AGENDA
REGULAR MEETING OF THE BIRMINGHAM PLANNING BOARD
WEDNESDAY JUNE 11, 2025 – 7:30 PM
151 MARTIN ST., CITY COMMISSION ROOM 205, BIRMINGHAM MI*

SUBJECT: 168 W. Maple – Teuta – Final Site Plan & Design Review

SUBJECT: 295 Elm St. – Forest Townhomes – Final Site Plan & Design Review

TEUTA

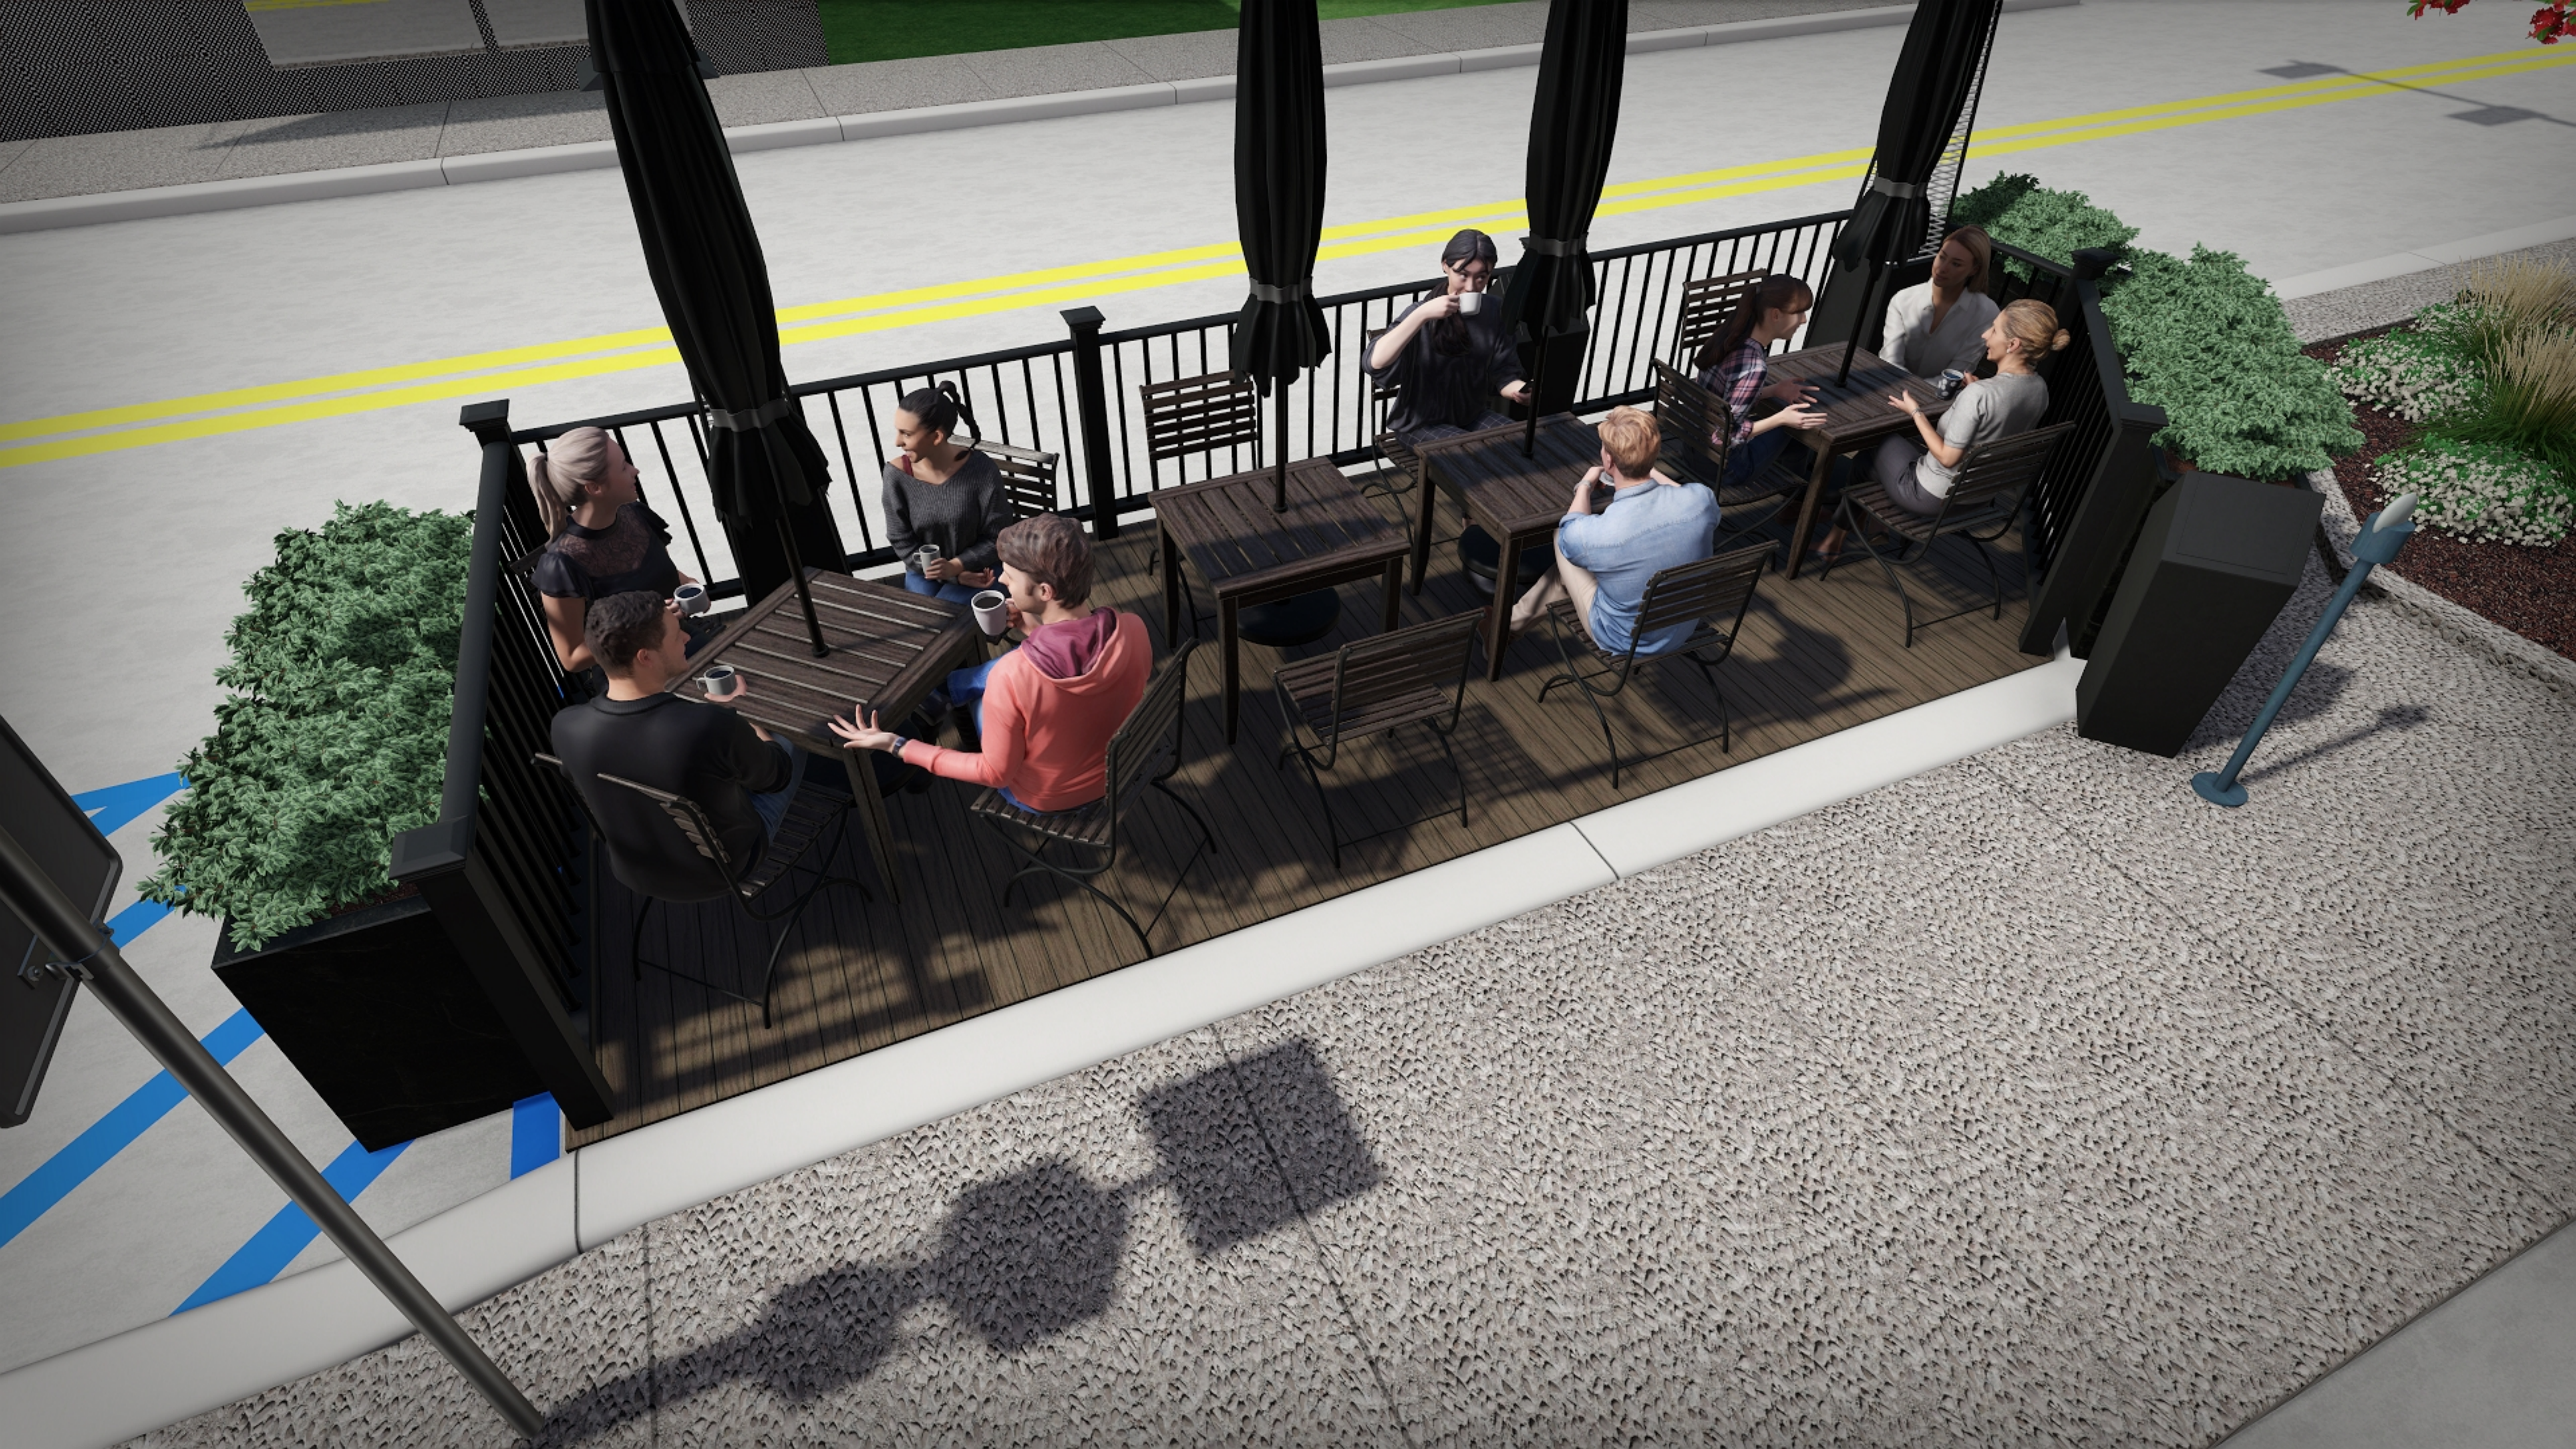
Teuta is proposing to have 12 seats at 4 tables, all of which are placed on an outdoor dining platform. There are 2 planters located within the amenity zone outside of the footprint of the platform. The outdoor dining platform will occupy one on-street parking space. There is 1 more planter located outside of the on-street parking space, within the ADA curb cut on the street. **This planter will need to be moved or removed as it will not be able to be located within the ADA curb cut.**

The site plan also appears to show one trash can outside of the platform within amenity zone. The applicant proposes trexdeck as the material for the proposed platform deck and proposes to construct the platform flush with the curb as required by the ordinance. **To properly assess the design of the deck, the applicant must submit details on all proposed outdoor dining elements including, but not limited to, overhead weather protection, heating elements, and trash receptacles. The applicant must also submit a scaled side view of the plans, showing the dimensions of the height of the deck railings.**

The proposed platform does not impact the pedestrian zone and will maintain the required 5 ft. continuous clear path for pedestrian passage between the building frontage and the outdoor dining furniture. The distance from the building face to the nearest outdoor dining elements is unknown, as it is not marked on the plans.

1. The applicant must submit revised plans without the planter within the ADA curb cut and to show the details of the vegetation included in the planters; and
2. The applicant must submit details on all proposed outdoor dining elements including, but not limited to, overhead weather protection, heating elements, and trash receptacles; and
3. The applicant must also submit a scaled side view of the plans, showing the dimensions of the height of the deck railings; and
4. The applicant must reimburse the city for all costs associated with moving the ADA space to the adjacent parking space (if eligible); and
5. The applicant must comply with the requests of all City Departments.

LANDSCAPE PLAN
SCALE: 1/8" = 1'-0"

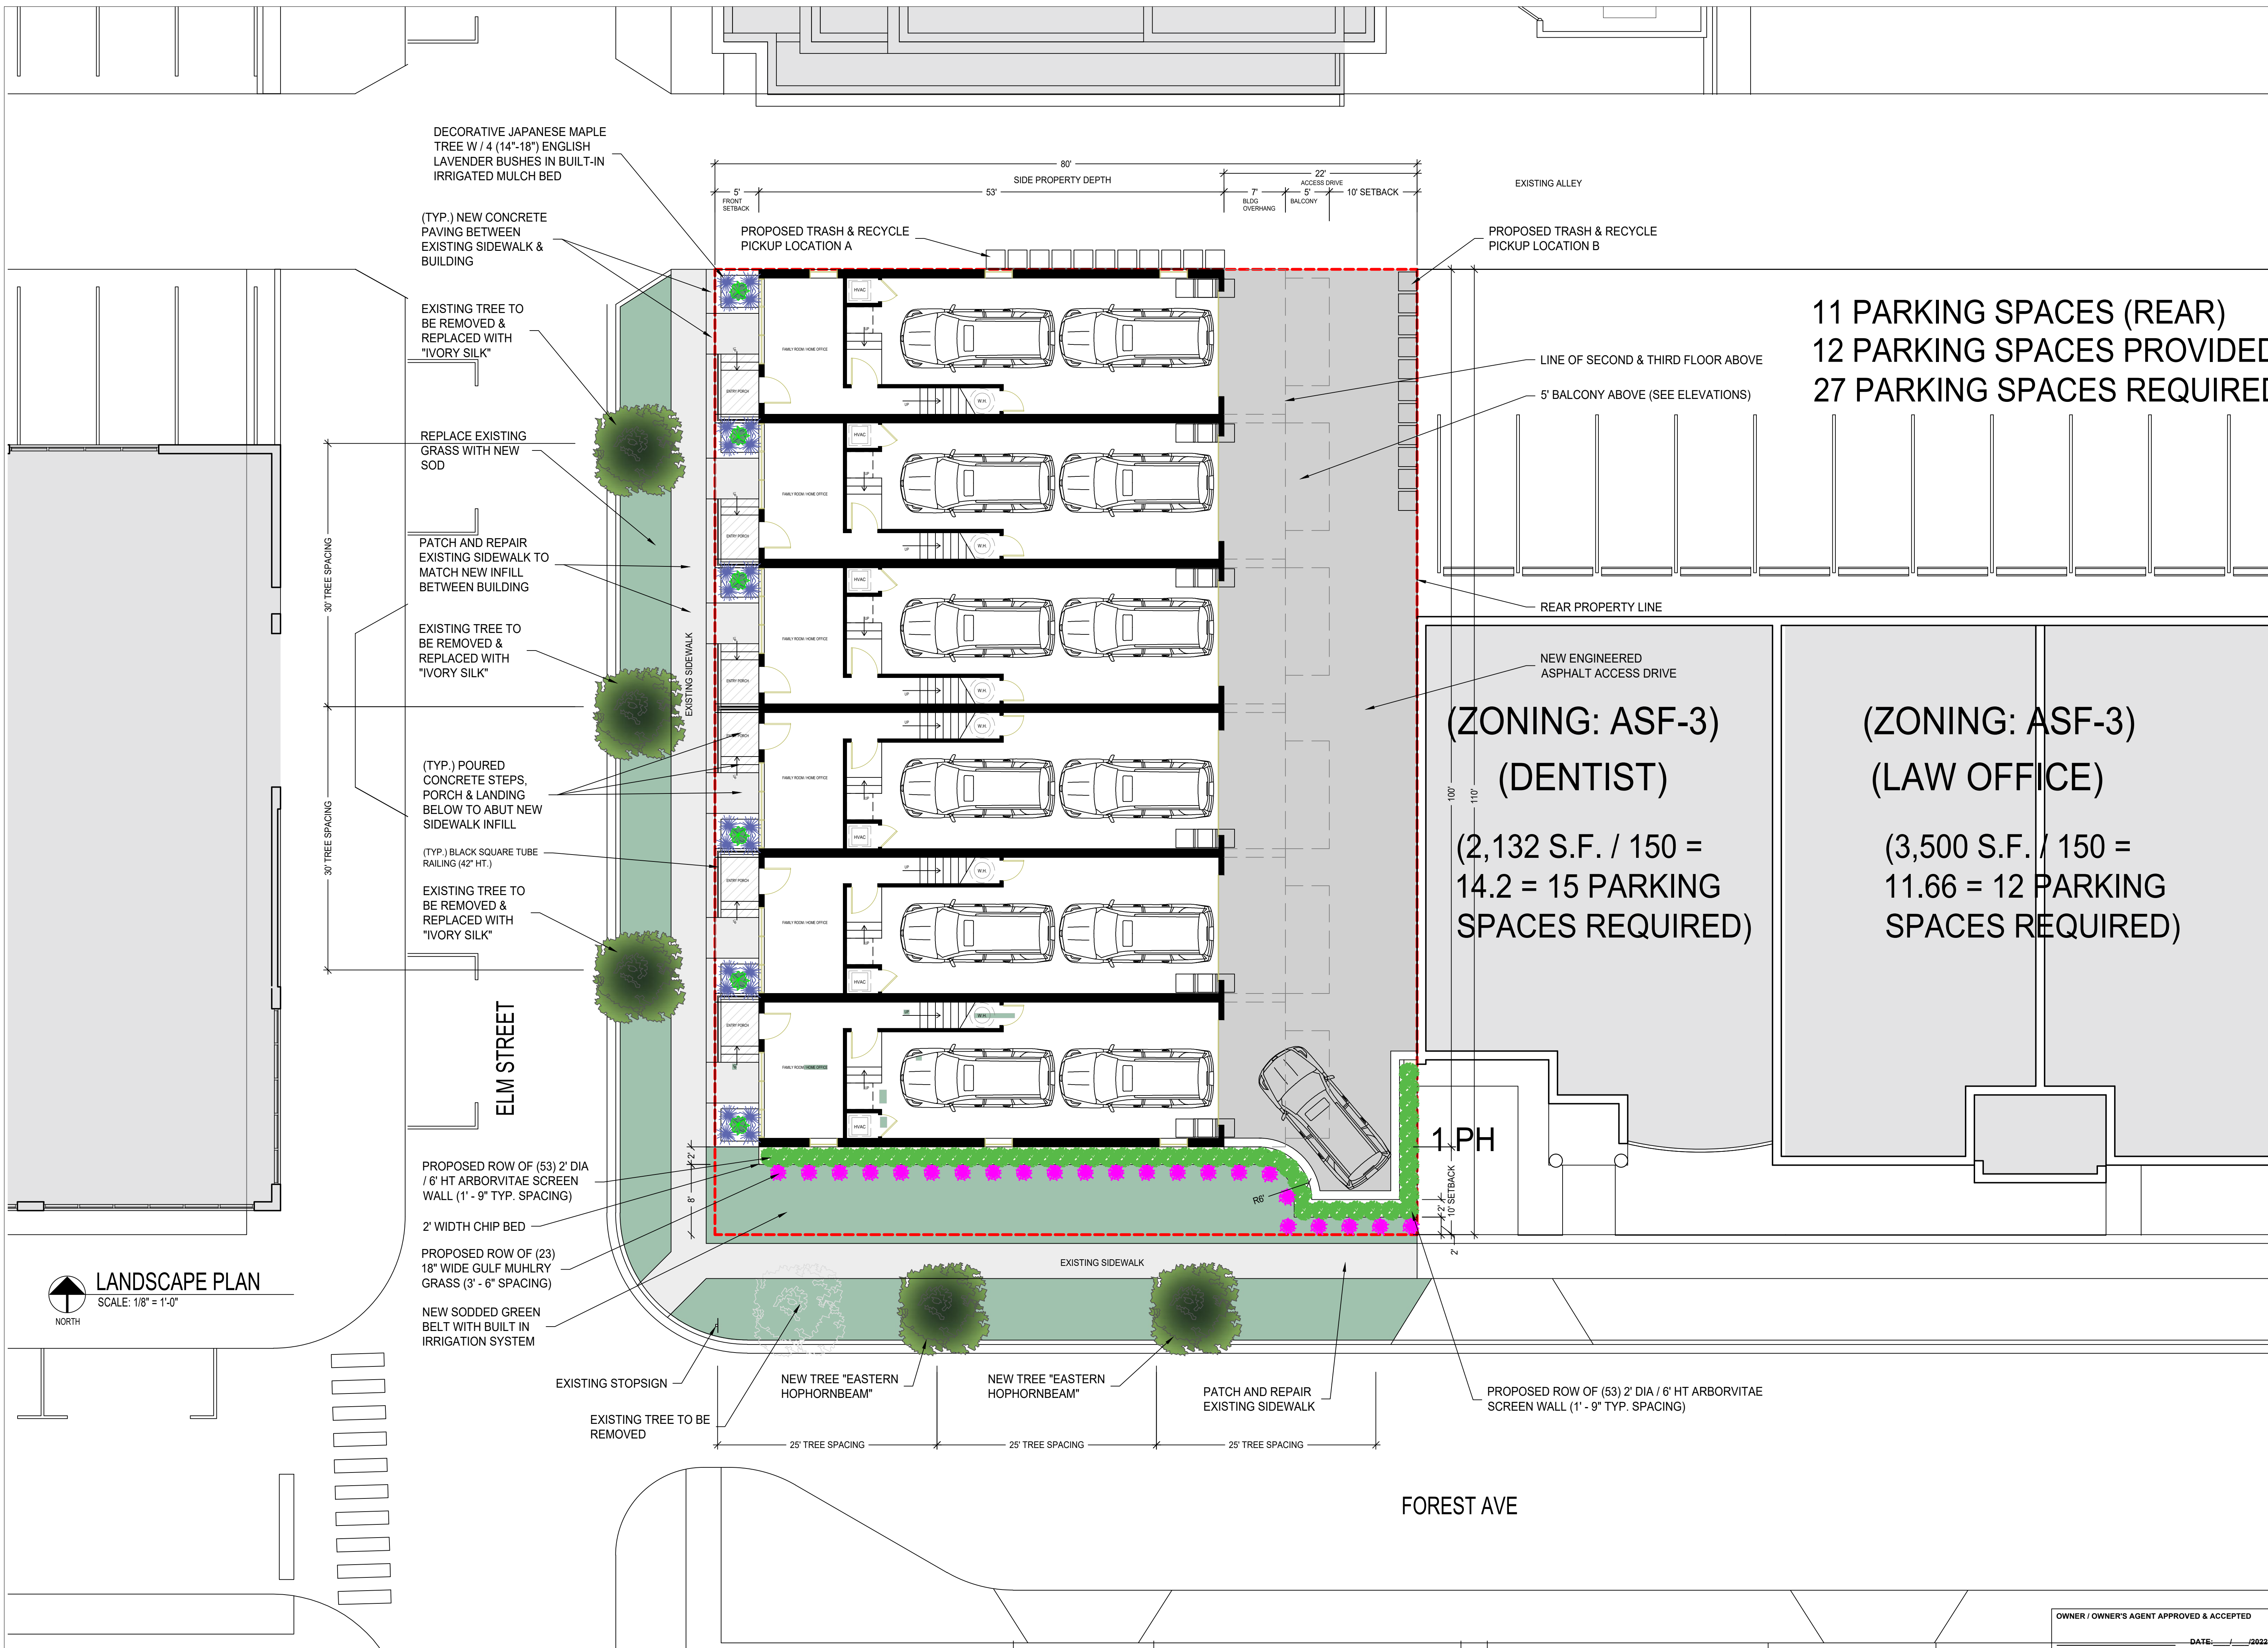
- 4.4 Landscaping – The applicant has submitted a landscape plan for the site which includes 6 planter boxes, one adjacent to each unit entrance containing a decorative Japanese Maple tree and English Lavender bushes. Additionally, the applicant is proposing a row of mature arborvitae along the south side of the property, as well as a row of Gulf Muhly grass and a sodded green belt with built in irrigation system.

Although landscaping is not required in the ASF3/O1 zones, multiple family development such as this in other zones typically require deciduous and evergreen tree plantings. Due to the multiple-family development proposal and the sensitive location in between commercial and single-family zones, the applicant has included a row of 6' tall arborvitae along the South façade of the building as well as a row of Gulf Muhly grass.
